**SSD DA – STAGE 2 NELUNE COMPREHENSIVE CANCER CARE (NCCC) AND AUSTRALIAN
ADVANCED TREATMENT CENTRE (AATC)
PRINCE OF WALES HOSPITAL – AVOCA & HIGH STREETS, RANDWICK**

I write, on behalf of NSW Health Infrastructure (HI), with reference to the above and in response to late submissions received by the Department from NSW Heritage Office and the RMS. This letter supplements our original Response to Submissions package as issued on 22 January 2014.

1.0 RESPONSE TO NSW HERITAGE OFFICE SUBMISSION

AR_01_1111

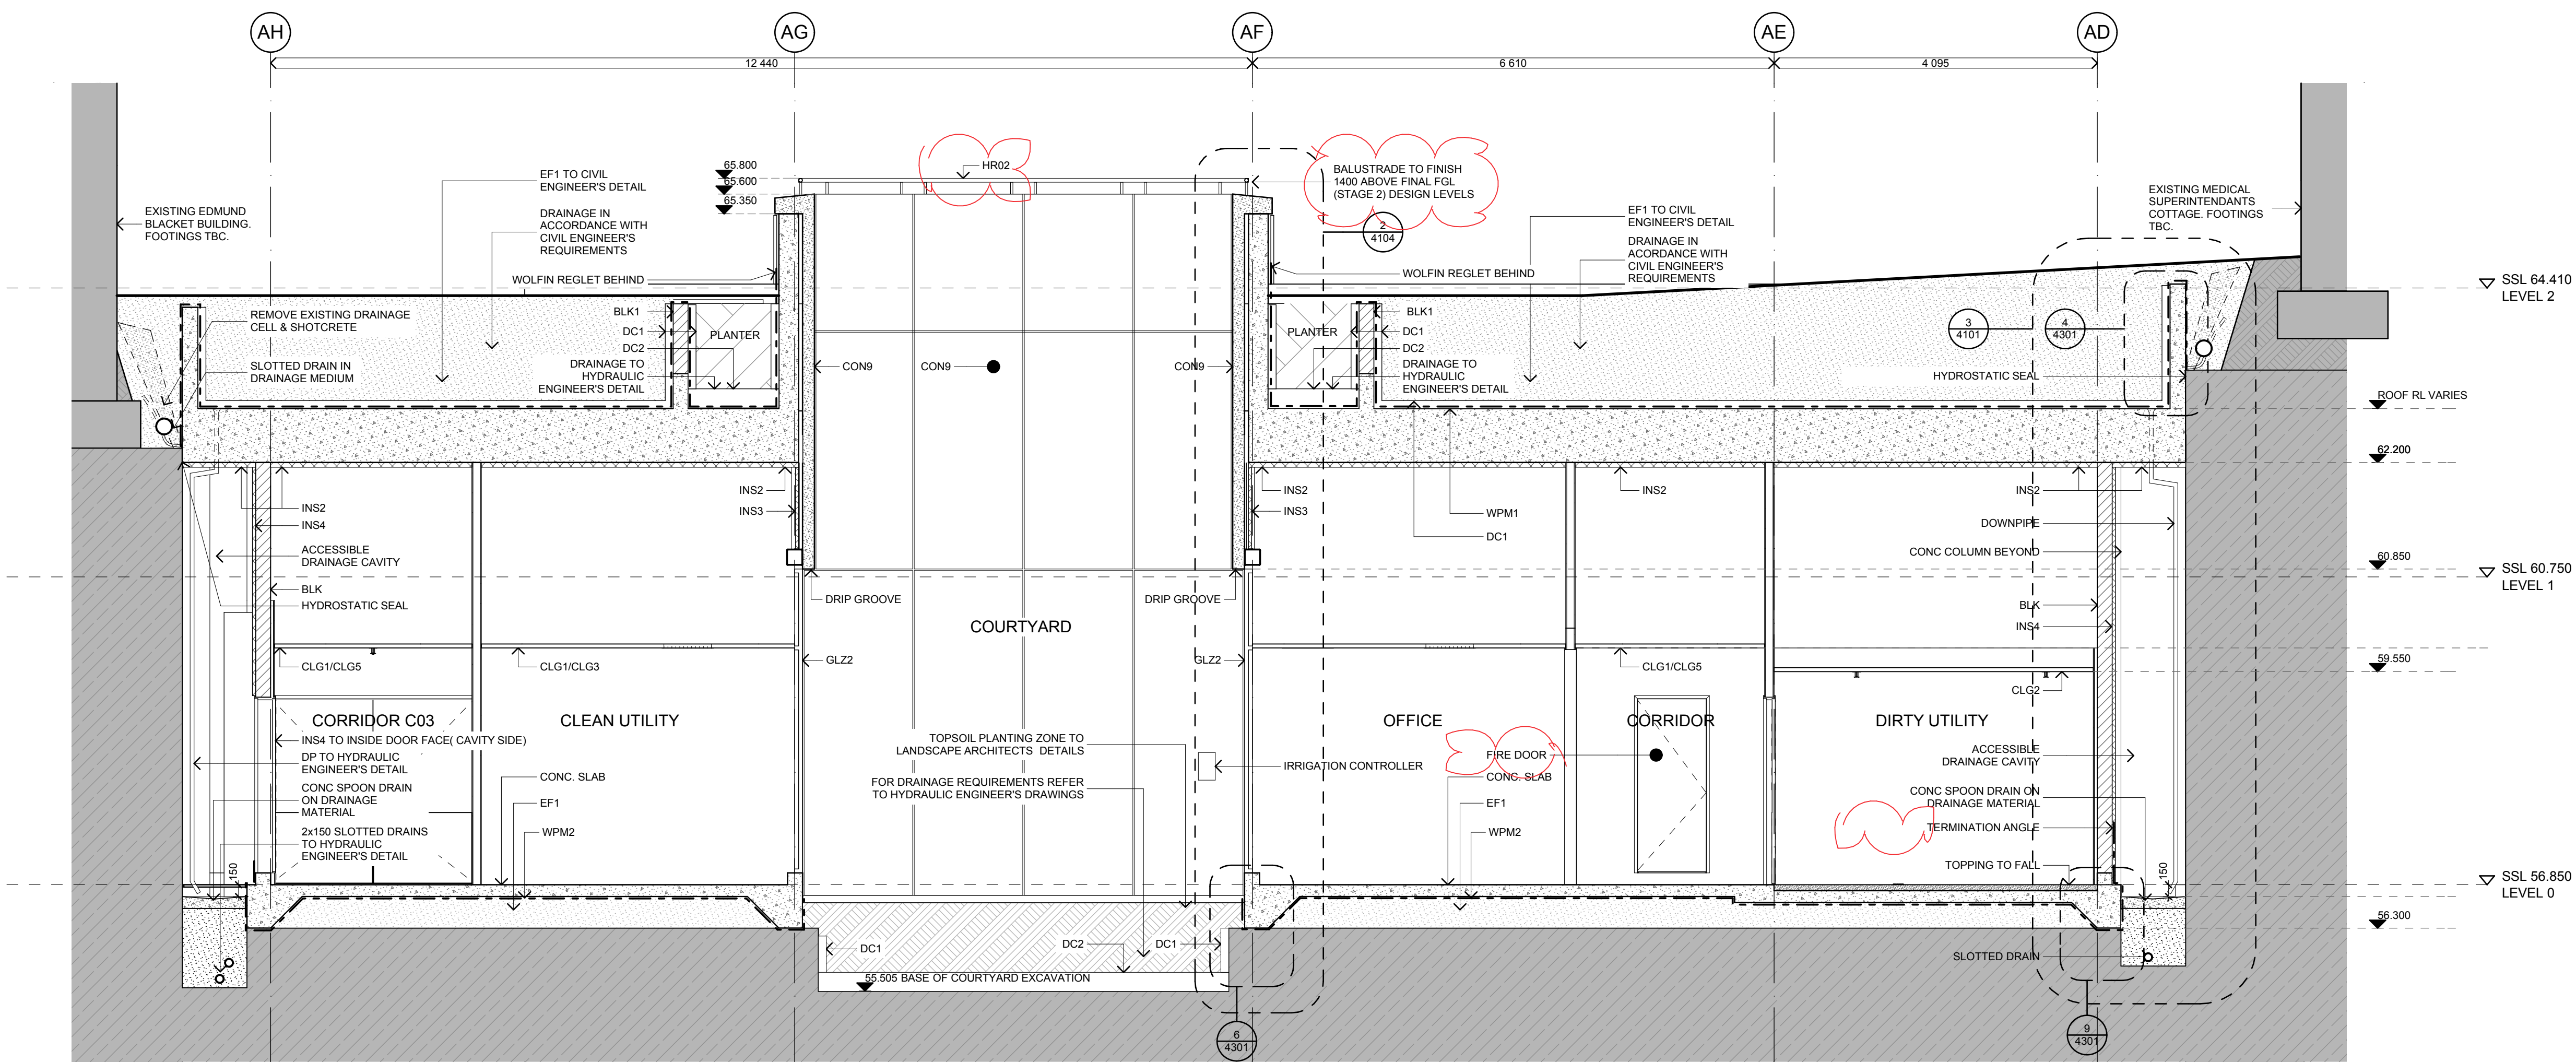
2. Further design and construction details on the materiality of the balustrade to the central light well and hard landscaping generally should be provided for assessment and approval.

The balustrade was approved as part of Stage 1 of the project. The balustrade serves to provide a barrier (meeting relevant Australian Standards in height, form and construction) to prevent vehicles falling/crashing from ground level into the sunken courtyard. The materials for the barrier / balustrade, as visible from the barrier's outside, are precast concrete panel and sill, galvanised steel balustrade and painted handrail and colour-backed glass with structural struts for the fixed glazing system. Please see attached drawings from Rice Daubney.
